Road & Bridge Design Publications

Monthly Update – June 2026

Revisions for the month of **June** are listed and displayed below and will be included in projects submitted for the **October** letting. The special detail index for **May** will remain in effect.

MICHIGAN DEPARTMENT OF TRANSPORTATION
 BUREAU OF DEVELOPMENT
 FACTORS FOR BRIDGE ESTIMATES

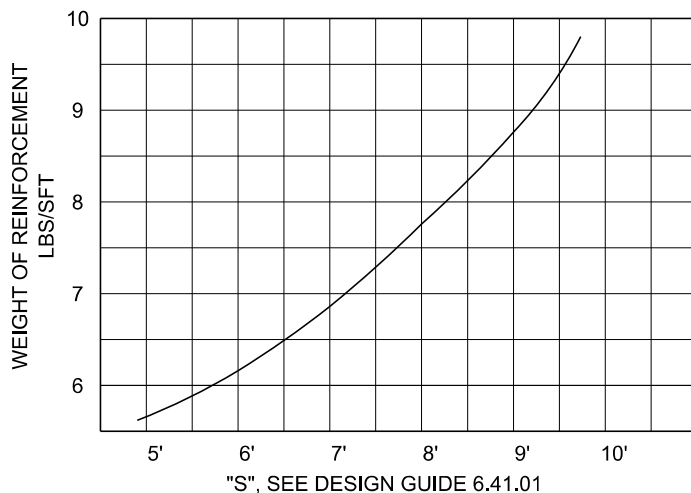
1.21.01: Factors for Bridge Estimates:

Corrected Superstructure Unit subsection title in the Steel Reinforcement Weights table.

MICHIGAN DEPARTMENT OF TRANSPORTATION
 BUREAU OF DEVELOPMENT
 BRIDGE RAILING, AESTHETIC PARAPET TUBE
 END WALL DETAIL

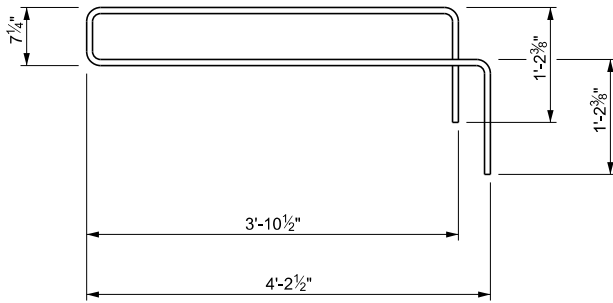
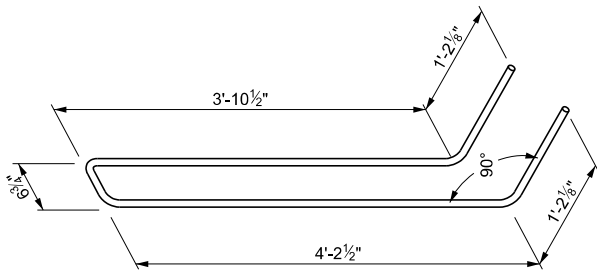
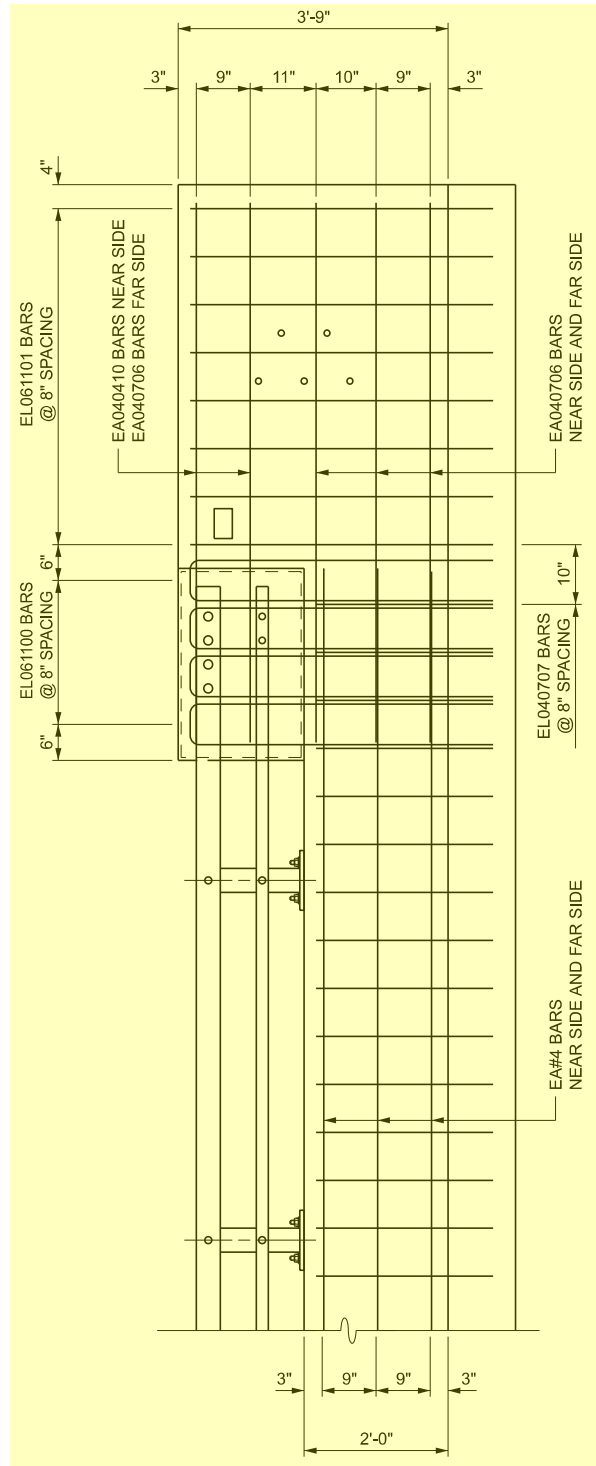
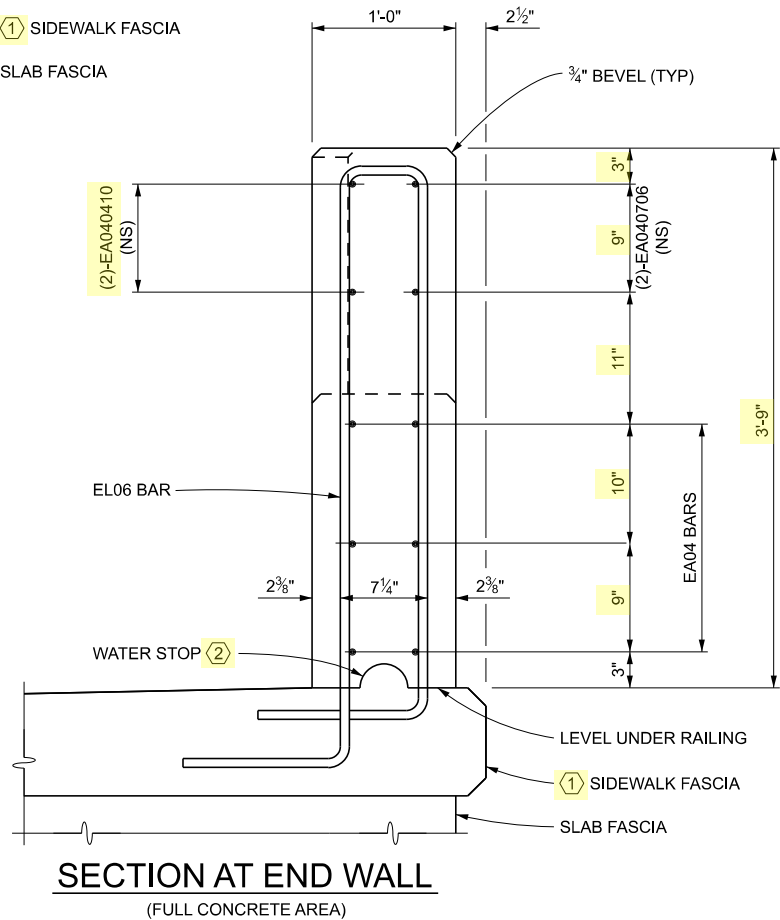
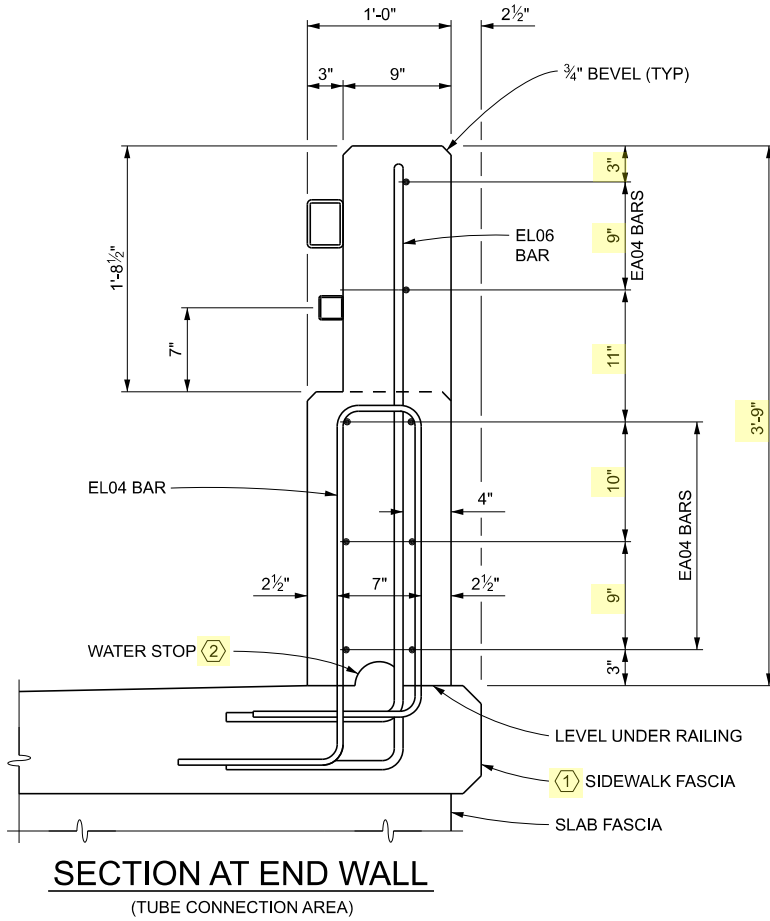
6.29.10A: Bridge Railing, Aesthetic Parapet Tube End Wall Detail:

Revised steel reinforcement in the Aesthetic Parapet Tube end wall and increased end wall section height to better accommodate guardrail anchorage connection.

PRESTRESSED CONCRETE 3 FT. WIDE
 BOX BEAM REINFORCEMENT DETAILS

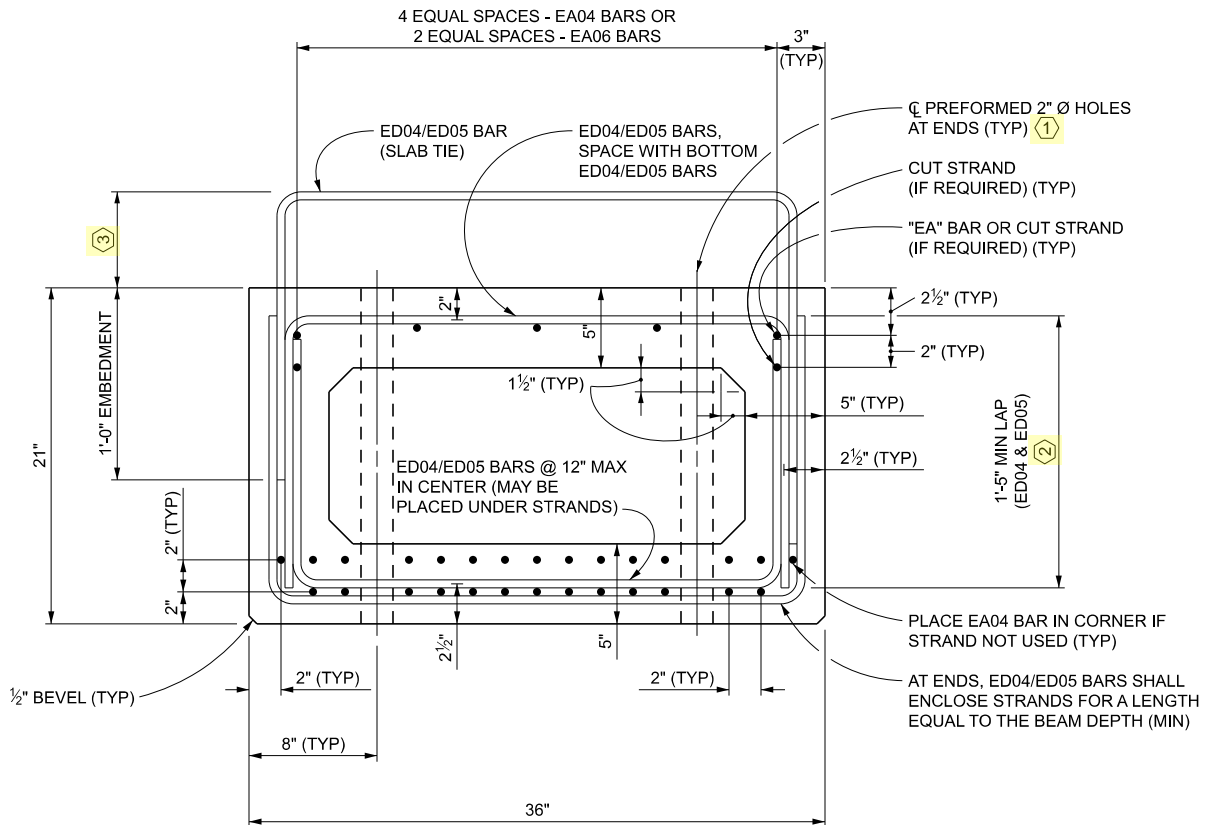
6.65.10, 6.65.10A, 6.65.10B, & 6.65.10C: Prestressed Concrete 3 ft. Wide Box Beam Details:

Updated Notes to new format. Added relevant reference to alternative reinforcement configuration shown in new Bridge Design Guides 6.65.10H or 6.65.10I.

FOR ALTERNATIVE REINFORCEMENT CONFIGURATION SEE 6.65.10H.

PRESTRESSED CONCRETE 4 FT. WIDE
 BOX BEAM REINFORCEMENT DETAILS

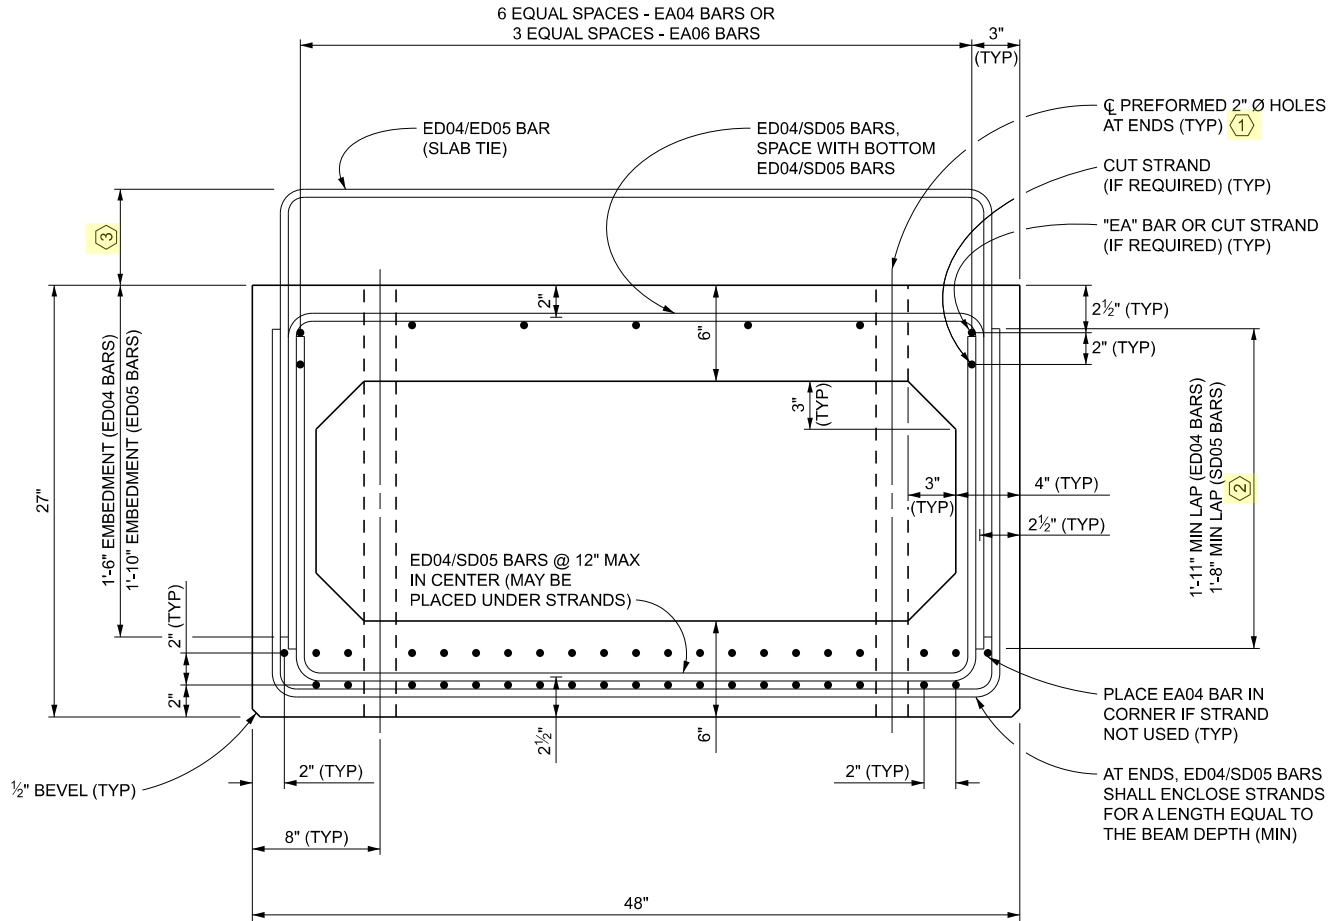
6.65.10D, 6.65.10E, & 6.65.10F: Prestressed Concrete 4 ft. Wide Box Beam Details:

Updated Notes to new format. Added relevant reference to alternative reinforcement configuration shown in new Bridge Design Guides 6.65.10H or 6.65.10I.

FOR ALTERNATIVE REINFORCEMENT CONFIGURATION SEE 6.65.10H.

MICHIGAN DEPARTMENT OF TRANSPORTATION
 BUREAU OF DEVELOPMENT
 PRESTRESSED CONCRETE 17 IN., 21 IN., AND 27 IN.
 BOX BEAM REINFORCEMENT ALTERNATIVE DETAILS

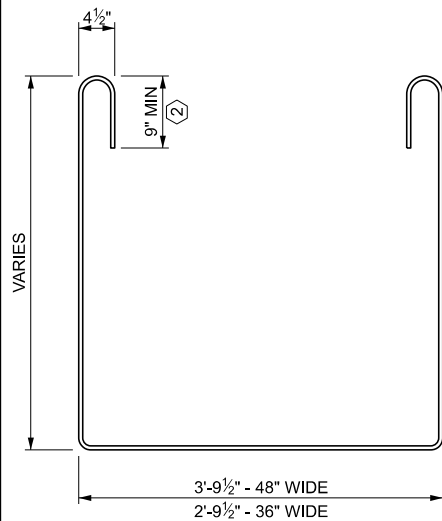
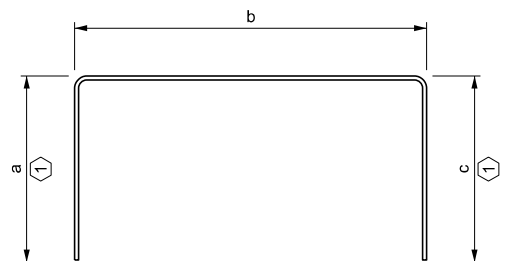
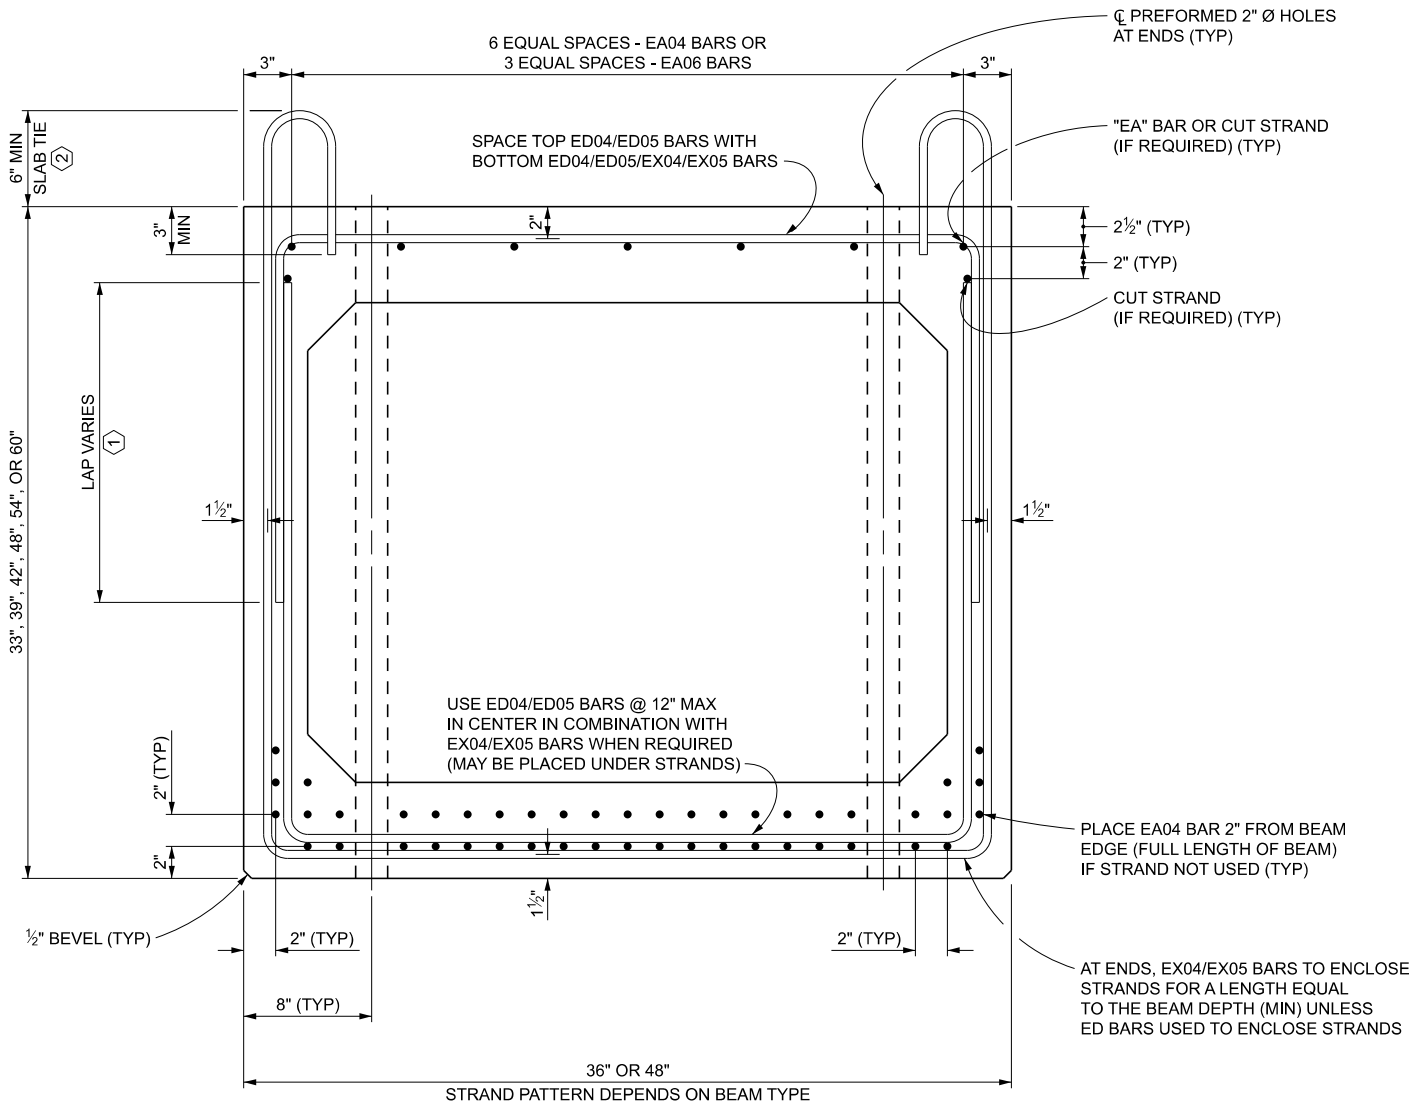
6.65.10H: Prestressed Concrete 17 in., 21 in., And 27 in. Box Beam Reinforcement Alternative Details:

New Bridge Design Guide that provide an alternative reinforcement layout for 17 in., 21 in., and 27 in. Box Beams. Alternative replaces current slab tie ED bars with alternative EX hooked bars.

MICHIGAN DEPARTMENT OF TRANSPORTATION
 BUREAU OF DEVELOPMENT
 PRESTRESSED CONCRETE 33 IN. THROUGH 60 IN.
 BOX BEAM REINFORCEMENT ALTERNATIVE DETAILS

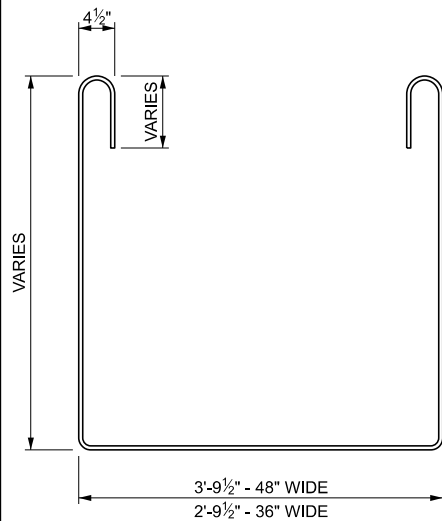
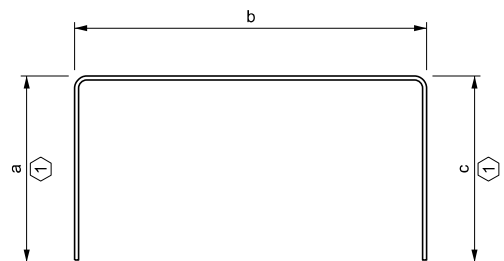
6.65.10I: Prestressed Concrete 33 in. Through 60 in. Box Beam Reinforcement Alternative Details:

New Bridge Design Guide that provide an alternative reinforcement layout for 33 in. Through 60 in. Box Beams. Alternative replaces current slab tie ED bars with alternative EX hooked bars.
